APPLICATION NO.	FILING DATE	FIRST NAMED INVENTOR	ATTORNEY DOCKET NO.	CONFIRMATION NO.
10/589,976	08/18/2006	Manabu Yagi	ASA-5487	2467
24956 7590 04/27/2009 MATTINGLY & MALUR, P.C. 1800 DIAGONAL ROAD SUITE 370 ALEXANDRIA, VA 22314				
EXAMINER				
WONGWIAN, PHUTTHIWAT				
ART UNIT		PAPER NUMBER		
3741				
MAIL DATE		DELIVERY MODE		
04/27/2009		PAPER

Office Action Summary

DETAILED ACTION

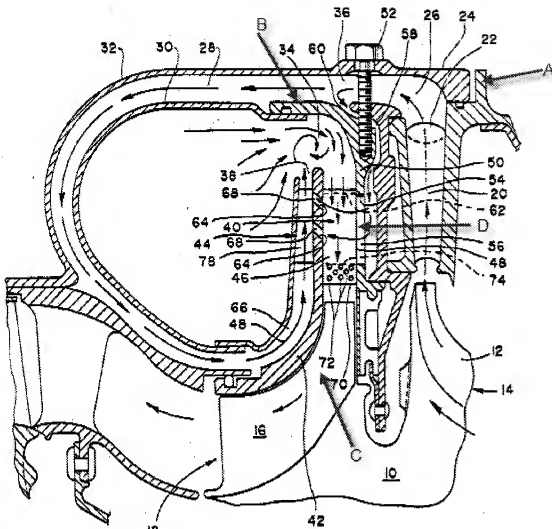
6. Claims 1, 10 and 19 are rejected under 35 U.S.C. 112, first paragraph, as failing to comply with the written description requirement. The claim(s) contains subject matter which was not described in the specification in such a way as to reasonably convey to one skilled in the relevant art that the inventor(s), at the time the application was filed, had possession of the claimed invention. The limitation "a combustor outer cylinder mounted **outside** the outer casing" was not described in the original drawing or specification, the drawing (Fig. 1, A) shows that the combustor outer cylinder 8 is **mounted to the casing 7**, not the outer casing.

16. As to claims 1, 10 and 19-20, Corrado discloses a radial turbine (fig. 1) comprising: an outer casing A (fig. 1, above); a scroll B (fig. 1 above) mounted inside the outer casing which forms a first part 34 (fig. 1) of a combustion gas flow path for guiding a combustion gas generated in a combustor (fig. 1) to a nozzle 40 (fig. 1) which injects the combustion gas to a radial impeller 16 (fig. 1) on an inner side in a radial direction of a rotary shaft (fig. 1); and a shell 42 (fig. 1) which covers the nozzle and the

impeller and forms a second part C (fig. 1 above) of the combustion gas flow path; an airtight air flow path 22 (fig. 1) formed between outside air in a substantially airtight state inside the casing; an air take-in hole 12 (fig. 1) which takes in air into the air flow path from the outside 14 (fig. 1); a combustor outer cylinder 24 (fig. 1 above) mounted outside the outer casing A (fig. 1 above); a combustor liner 30 (fig. 1) mounted inside the combustor outer cylinder 24 (fig. 1), which is communicated with the scroll B (fig. 1 above) and guides the combustion gas into the scroll; a blow-off hole 38 (fig. 1) which guides a first part of the air taken into the air flow path, into the combustor liner; and through holes D, 68 (fig. 1 above) extending through the shell from the air flow path on both sides of the nozzle adjacent a front edge of the nozzle and inclined at an angle 68 (fig. 1) toward a direction of flow of the combustion gas to inject a second part of the air taken into the air flow path into the combustion gas passing through the nozzle.

17. As to claims 2-3 and 11, Corrado discloses that the air flow path is formed to cover an outer side 22, 28 (fig. 1) of the combustion gas flow path communicating from the combustor to the shell, and the through-holes D, 68 (fig. 1 above) is formed in walls of the shell 42 (fig. 1) at a portion upstream of the nozzle.

18. As to claims 5 and 14, Corrado discloses a plurality of the through-holes D, 68 (fig. 1 above) are arranged in parallel along a direction of flow of the combustion gas flow path.

19. As to claims 9 and 18, Corrado discloses a through-hole D, 68 (fig. 1) which leads from one side of the air flow path sandwiching the combustion gas flow path to the other side of the air flow path while penetrating a wall 42 (fig. 1) of the shell, a blade

thick 46 (fig. 1) portion of the nozzle and a wall of the shell on the other side; and a leakage hole 72 (fig. 1) which leads from the blade thick portion of the nozzle of the through-hole to a surface of the nozzle.

20. As to claim 12, Corrado discloses the air flow path 22, 28 (fig. 1) is formed to cover an outer side of the combustion gas flow path communicating from the combustor to the shell 42 (fig. 1), and the through-holes D, 68 (fig. 1 above) are formed in the walls of the shell at a portion upstream of the nozzle.
